**2006 IRC
Recommended Action for IRC Section R602.10.5
Continuous Structural Panel Sheathing (Wall Bracing)**

The State of New York Adopted 2006 IRC that begins August 2007

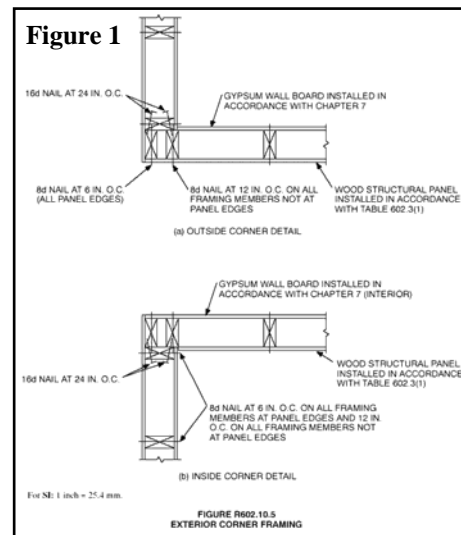
The concept behind the method is that the sheathing above and below openings (window and doors) and on adjacent walls at corners prevents rotation (overturning) of braced wall panels under lateral loading. However, the wording of this section does not make it clear that all parts of the walls have to be sheathed for this method to work as intended.

Without these clarifications, it is possible that this method could be used on one wall only, with the rest of the walls using the conventional braced wall panel method. If this were done, there may not be sheathing on adjacent walls to prevent overturning of the braced wall panels in the continuously sheathed wall.

A more appropriate solution to the above concern would have been to clarify that the corner detail in Figure R602.10.5 (see Figure 1 above) requires a minimum 2-foot corner return panel at the ends of a continuously sheathed braced wall line. This would appropriately allow a transition to other bracing methods on other wall lines while also properly adhering to the research data that supports the continuous sheathed bracing method first introduced in the 2000 IRC.
